KIRKLEES CULTURAL HEART

Proposed Planning
Amendments and Further
Detail of Submitted Design

WEST INFILL ELEVATION

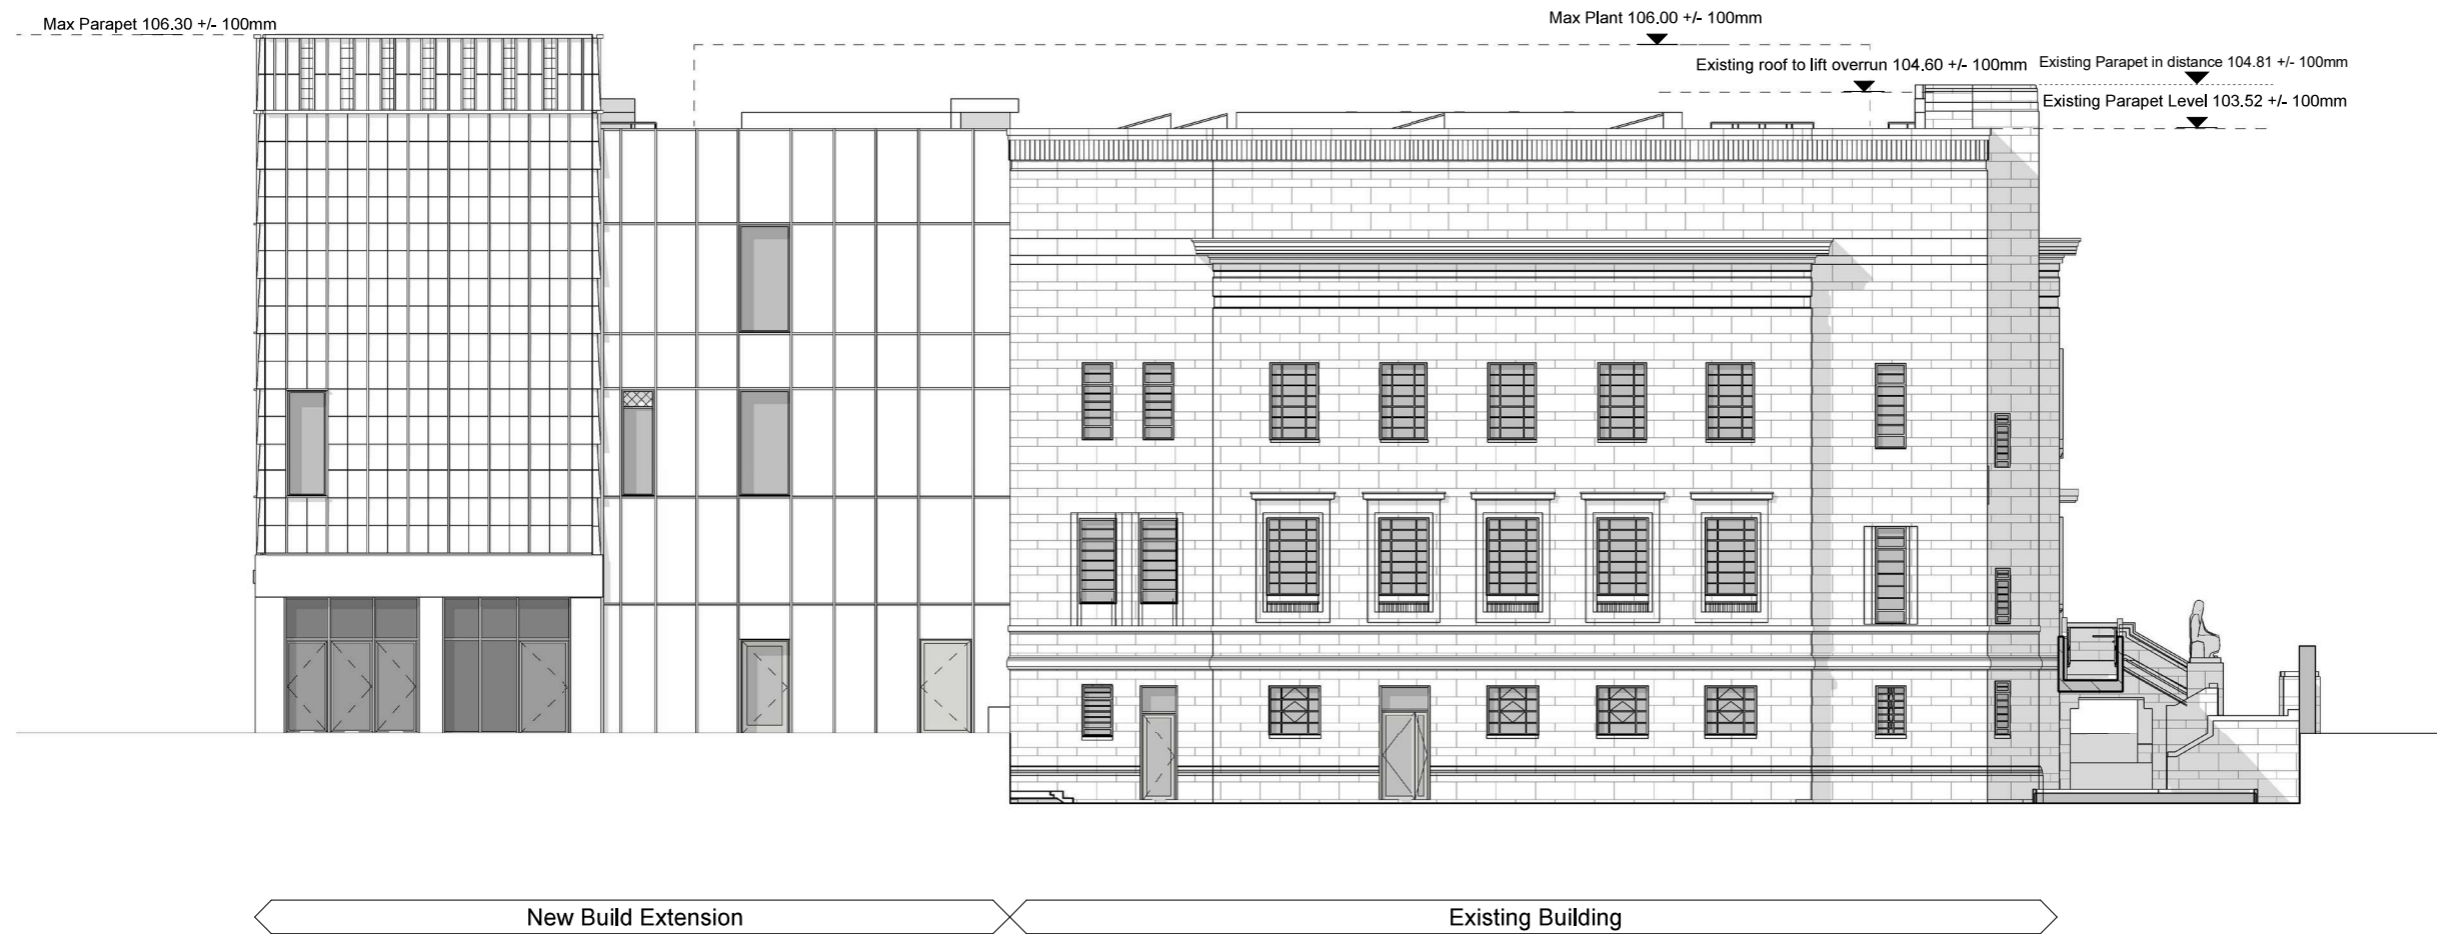
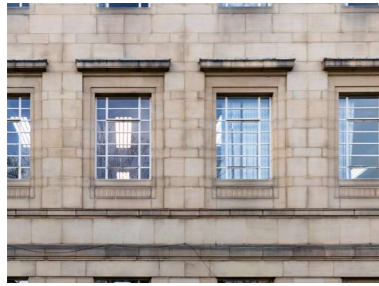
Reduced mullions to accentuate horizontals & perforate panels in front of windows/ false windows. Signage zone shown indicatively on new stone extension.

WEST INFILL ELEVATION VIEW 01

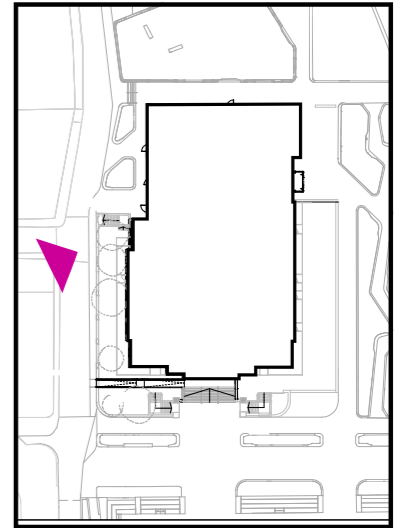
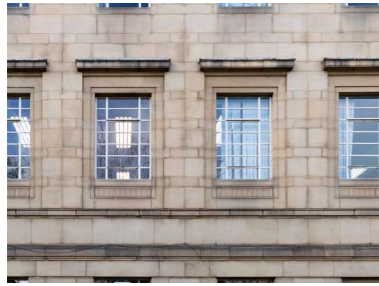
Proposed Amendment 1
Reduced mullions to accentuate horizontals & perforate panels in front of windows/ false windows. Signage zone shown indicatively on new stone extension.

Proposed Amendment 2
As Proposed Amendment 1 with lighter contrasting metal

WEST INFILL ELEVATION VIEW 02

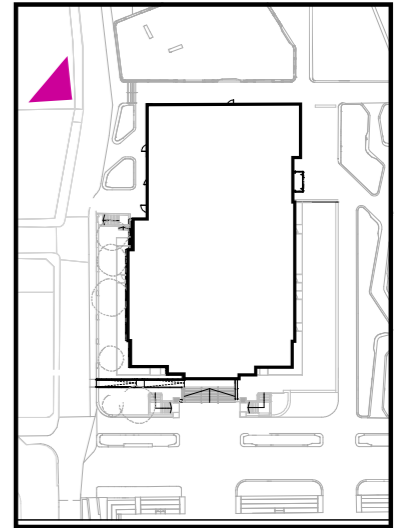
Proposed Amendment 1
Reduced mullions to accentuate horizontals & perforate panels in front of windows/ false windows. Signage zone shown indicatively on new stone extension.

Proposed Amendment 2
As Proposed Amendment 1 with lighter contrasting metal

SOUTH FACADE STUDY

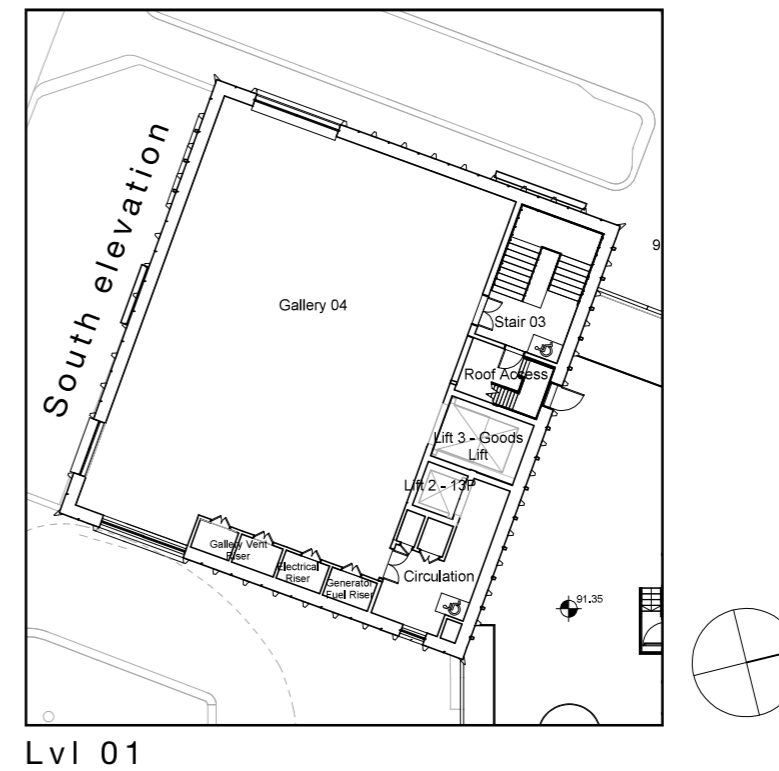
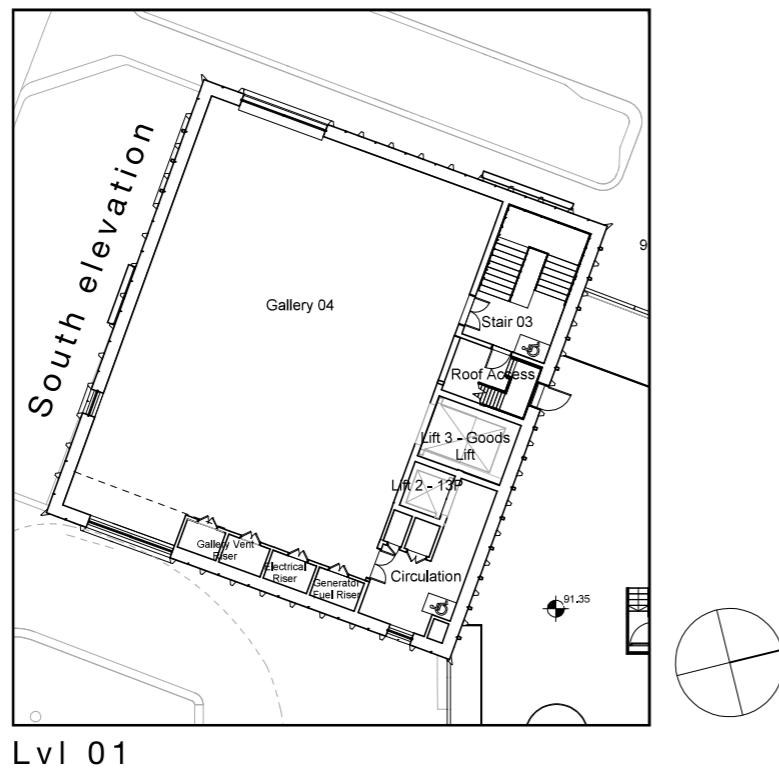
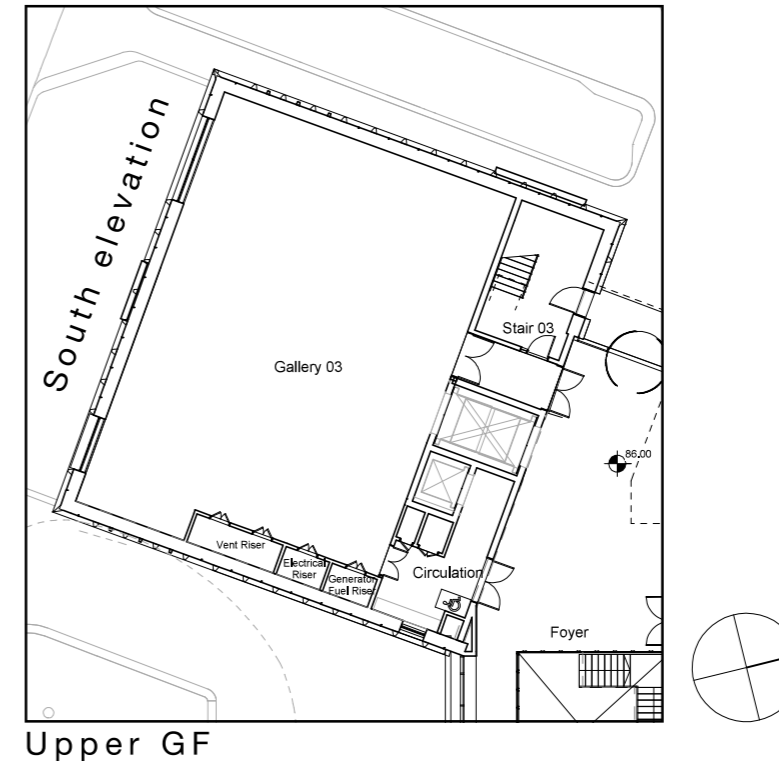
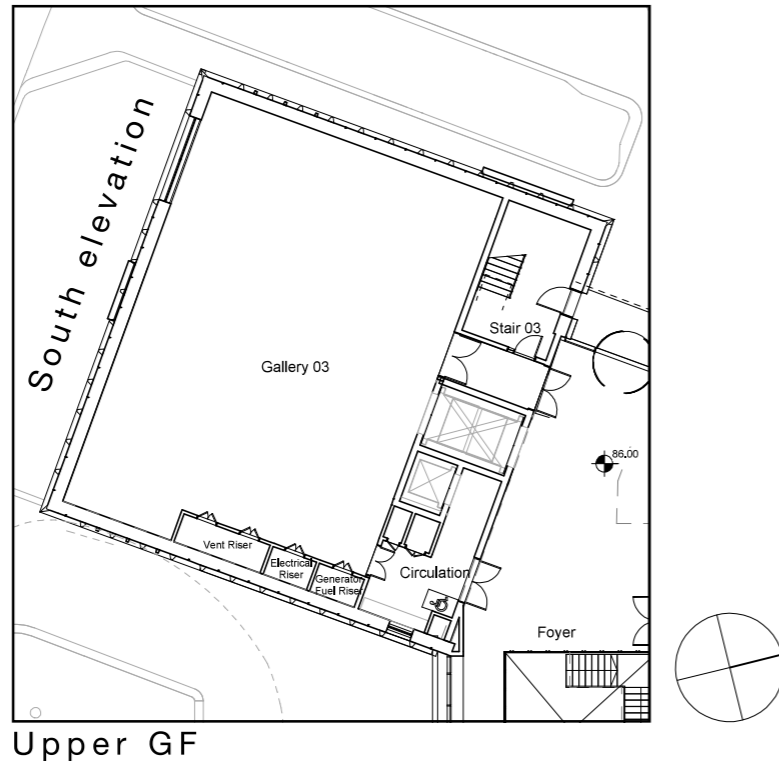
Proposed Amendment -
Additional and wider windows + shifted across one bay

1 Bay Study Elevation 03 - Ceramic + Louvred Panels
1:50

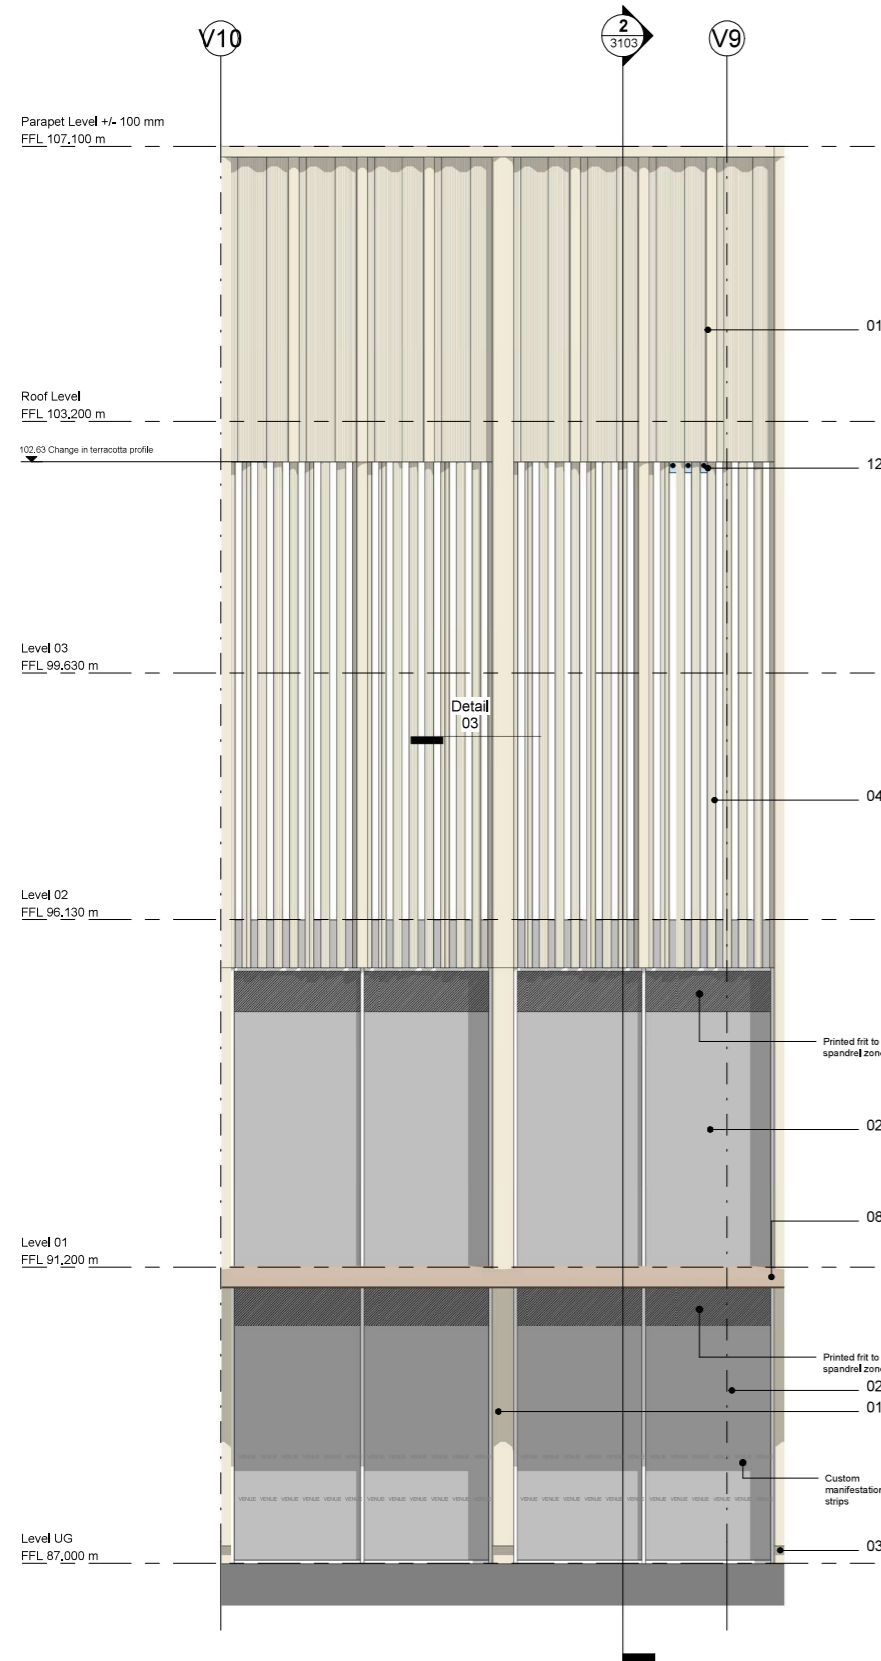
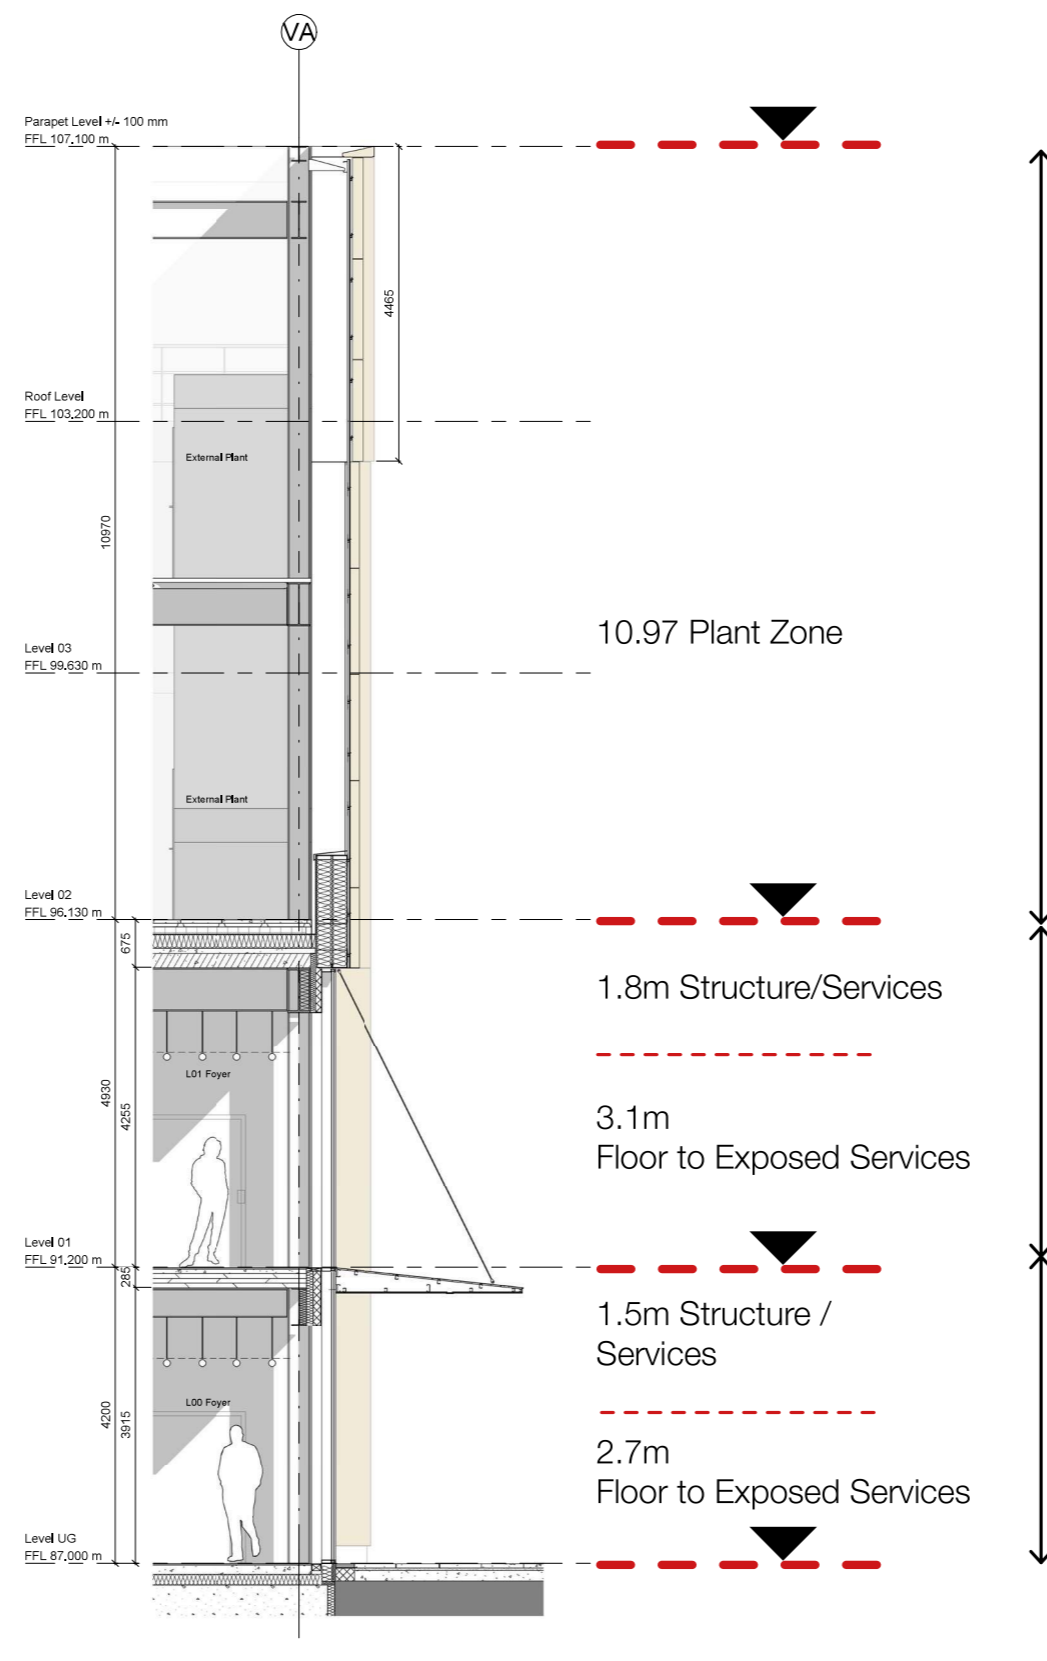
10.97m
Roof to Parapet
Total Plant Zone required
